BEFORE THE SOUTH DAKOTA PUBLIC UTILITIES COMMISSION

DOCKET NO. HP07-001

IN THE MATTER OF THE APPLICATION OF TRANSCANADA KEYSTONE PIPELINE, LP

Surrebuttal Testimony of William Walsh on Behalf of the Staff of the South Dakota Public Utilities Commission November 28, 2007

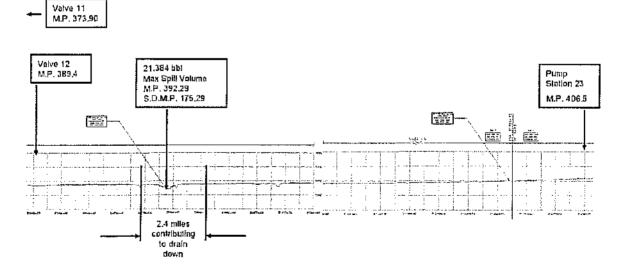
The amount of product escaping during the static phase is based on the volume between valve locations. All the volume is allowed to escape except that volume trapped due to the elevation profile. In the example, of the 41.4 miles between Pump Station 23 (M.P. 406.5 – total pipeline) and isolation valve 11 (M.P. 373.90 – total pipeline), all but 2.4 miles are trapped due to the elevation profile. This converts into a volume of 12,765 barrels released during the static phase from drain down. The total spill volume is estimated as 21,384 barrels – 8,619 barrels during the dynamic phase and 12,765 barrels during the static phase. The figure below illustrates the situation on the hydraulic profile sheet provided by Keystone in response to Data Request 6-35.

The figure assumes that South Dakota M.P.1 used in Mr. Thomas's rebuttal is equal to M.P. 217 based on the total pipeline. The example location South Dakota M. P. 175.29 would correspond to pipeline M.P. 392.29. If the mile post number conversion is correct, the pipeline segment lies between Valve 12 at M.P. 389.4 and pump station 23 at M. P. 406.5 as shown above.

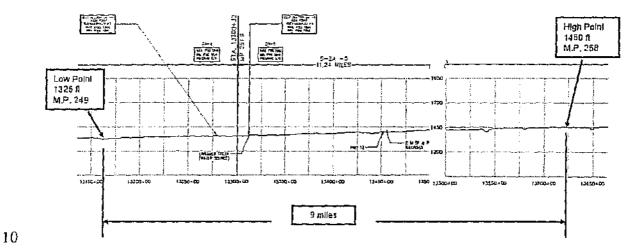
In my original testimony, I stated that the estimated leak value estimates were low, particularly for pipeline regions in the northern portion of the state. The revised estimates are lower still. Below is a plot of the pipeline segment on the hydraulic profile plot from M.P. 249 to M.P. 258. The difference in elevation is 125 feet between the locations. The gradual slope is relatively constant between these 2 locations. The Keystone model suggests that the total volume of drain down is less than 2.4 miles for this segment even if a leak occurred at the low point.

It is not obvious that any of the pipeline volumes shown above would be trapped due to the elevation profile. I therefore repeat my request that Keystone submit the assumptions used in the calculations of the spill volumes for review prior to the hearing. These assumptions may include criteria for determining what constitutes a trapped volume due to an elevation profile or any vacuum or siphon effects.
